SOUTH CAROLINA ELECTRIC & GAS COMPANY

May 16, 1972

RE: Virgil C. Summer Nuclear Station  
Docket No. 50-395

In response to your letter of May 2, 1972, we are submitting the attached answers to your questions. As you requested, forty-five (45) copies of the answers are submitted.

Figure 2SA.4-5  
 Surface Circulation Patterns  
 Fairfield Pumped Storage Plant Shut Down

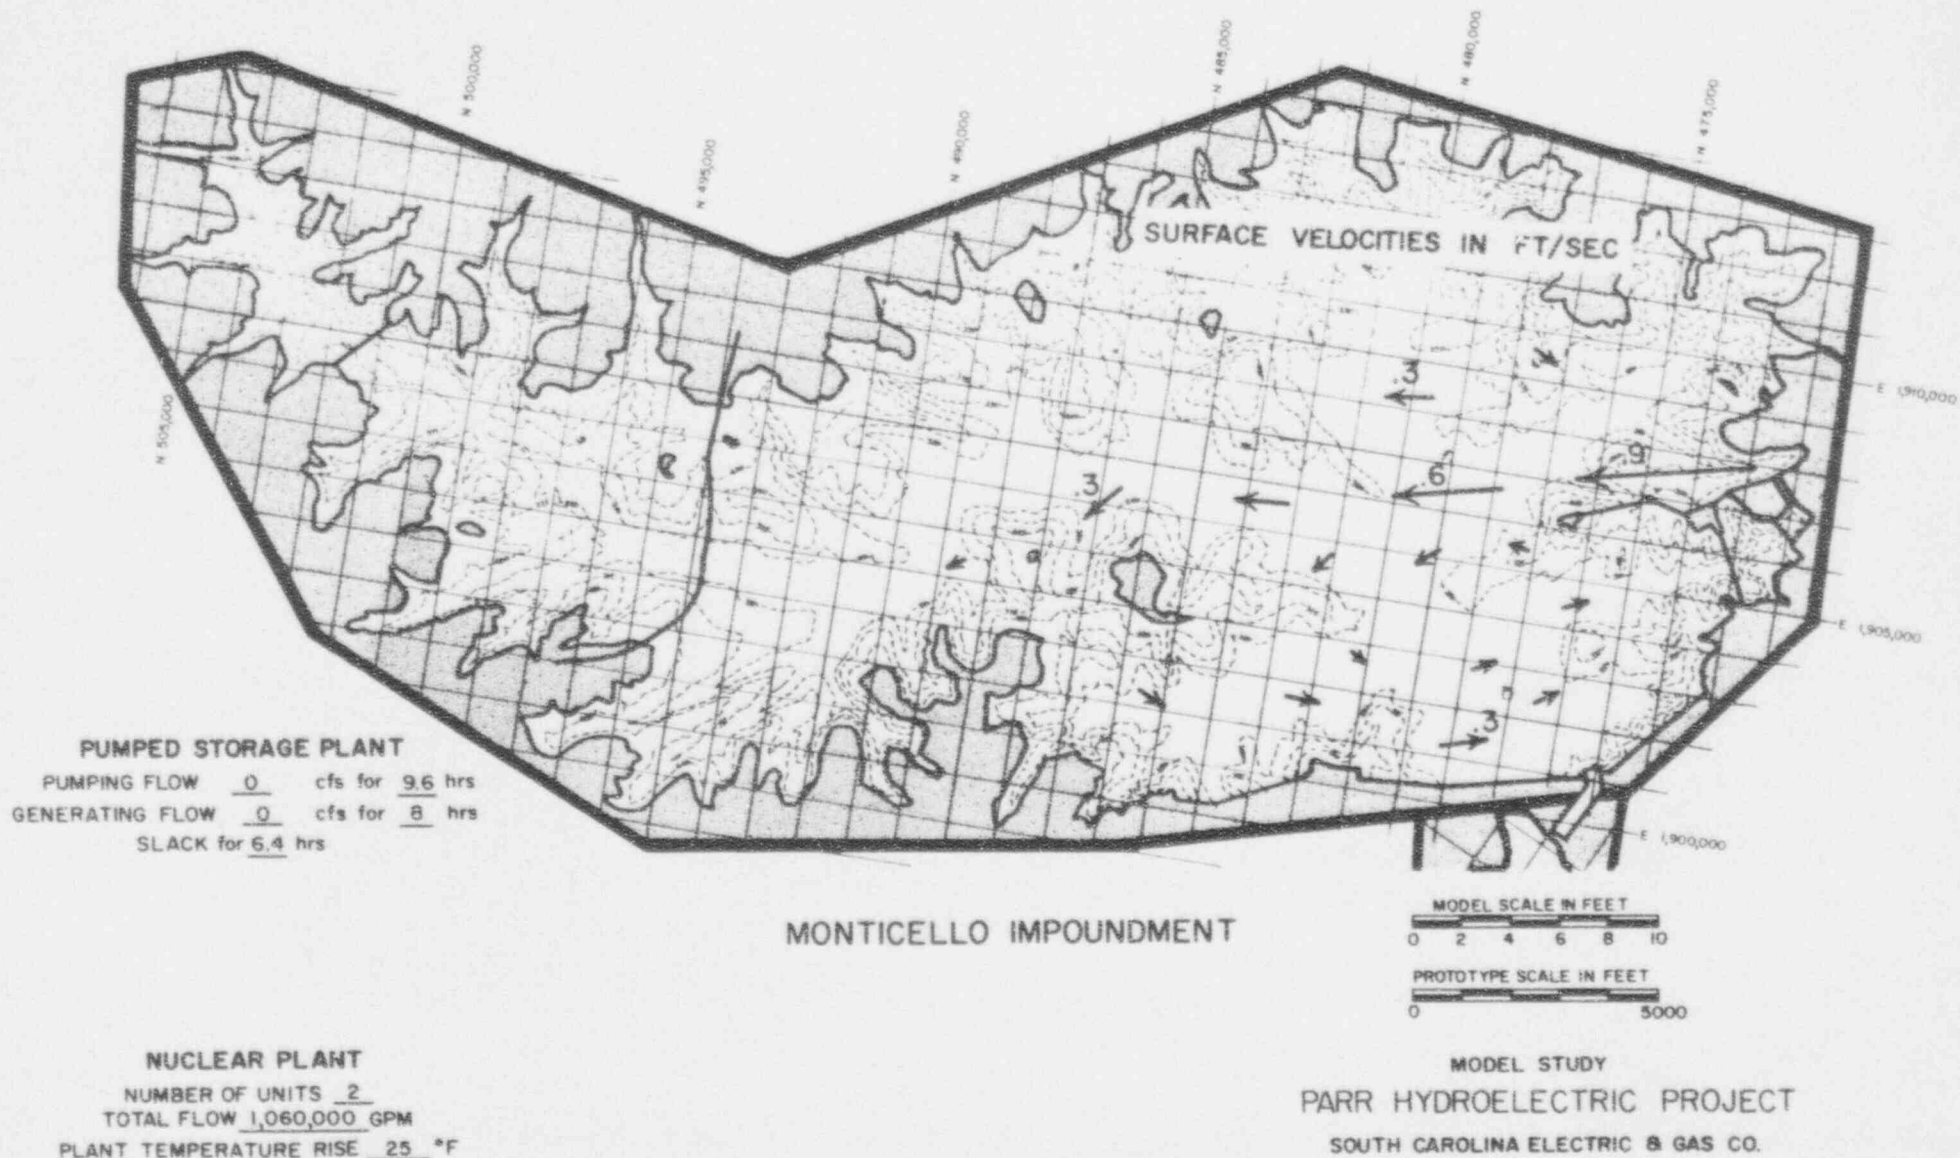
2SA.4 QUESTION: Provide data on the monthly maximum, minimum and average stream flows between the two water bodies and indicate how the outflow between the lake and the reservoir contributes to surface circulation of the lake.

South Carolina Electric & Gas Company expects the maximum monthly mean for stream flow between Monticello and Parr Reservoirs to be 11,973 CFS and to occur during the peak month of August. The minimum monthly mean stream flow will be approximately 5000 CFS and will occur in April. The monthly mean average flow is approximately 7000 CFS. The flow would be zero when the pumped storage plant is shut down.

Figures 2SA.4-1 and 2SA.4-2 show the surface circulation in the Monticello Impoundment when the pumped storage plant is under full load, Figures 2SA.4-3 and 2SA.4-4 for the average plant load and Figure 2SA.4-5 when the pumped storage plant is shut down.

FIGURE 3S.1-1

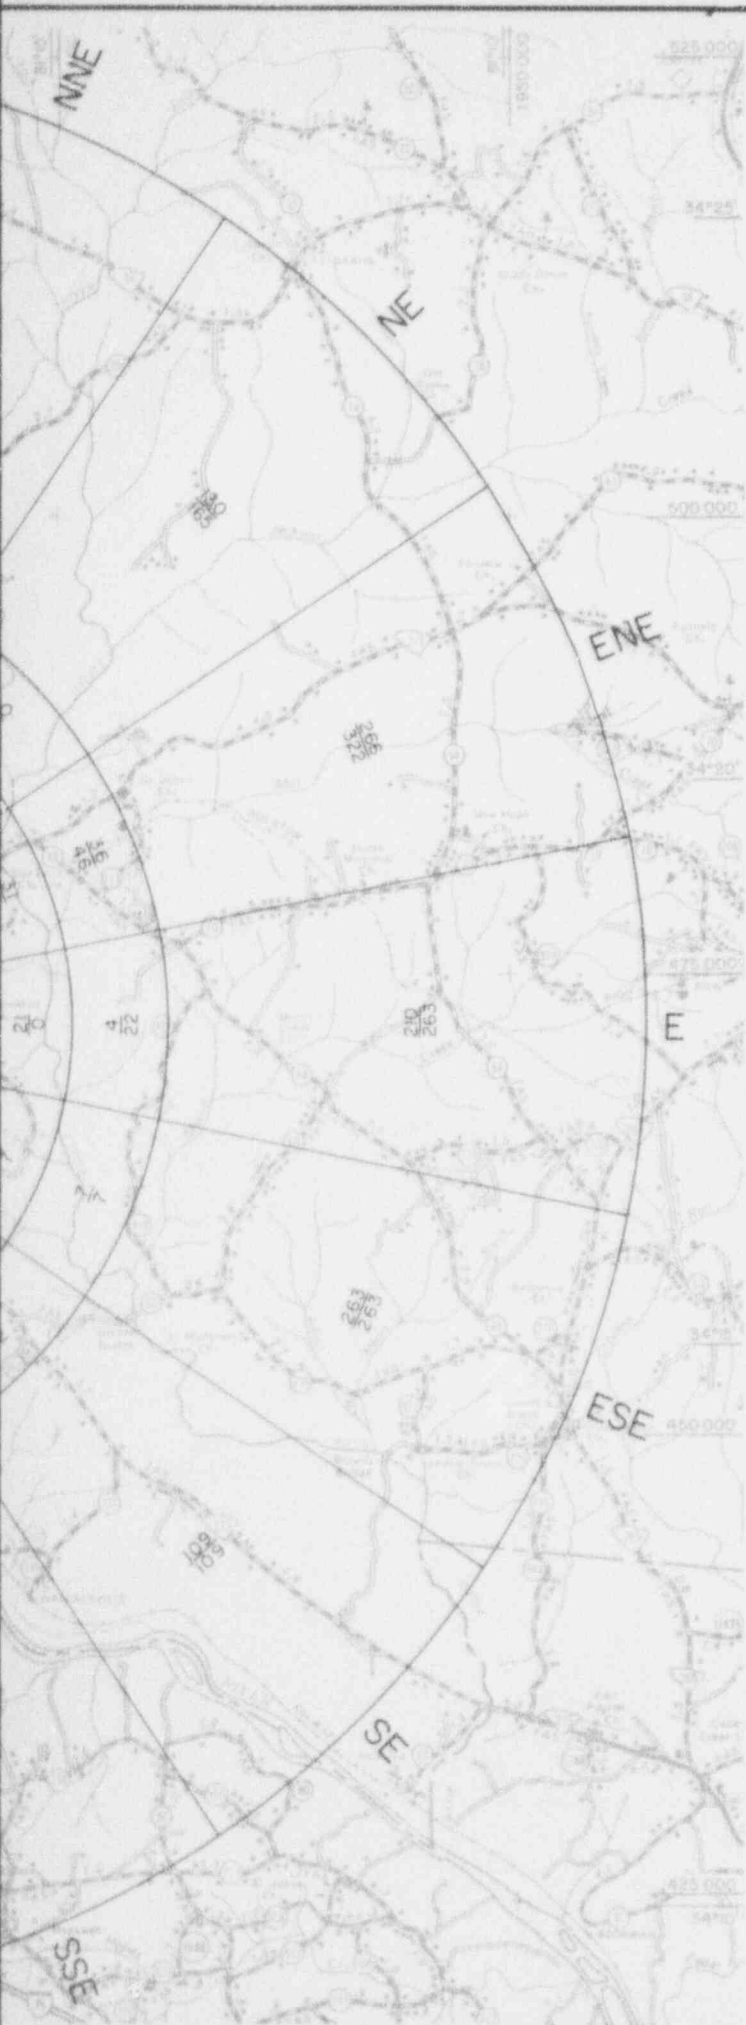
3S.1 QUESTION: Examination of the population data presented in the Environmental Report indicates that the data are unusable to determine the radiological impact of the plant due to the lack of alignment of the directional sectors. In the first 10 miles there are 16 sectors which are bounded by the cardinal compass points. With this arrangement, there is no way to utilize the meteorological data centered on the compass points with the population data. Provide population data for the first 10 miles, reoriented so as to be centered on the compass points. Redistribute the data out to 50 miles so they are divided into 16 sectors.

Figure 3S.1-1 presents population data divided into 16 sectors centered on the cardinal compass points for the first 10 miles from the reactor building. Figure 3S.1-2 presents population data out to a distance of 50 miles, divided into 16 sectors.
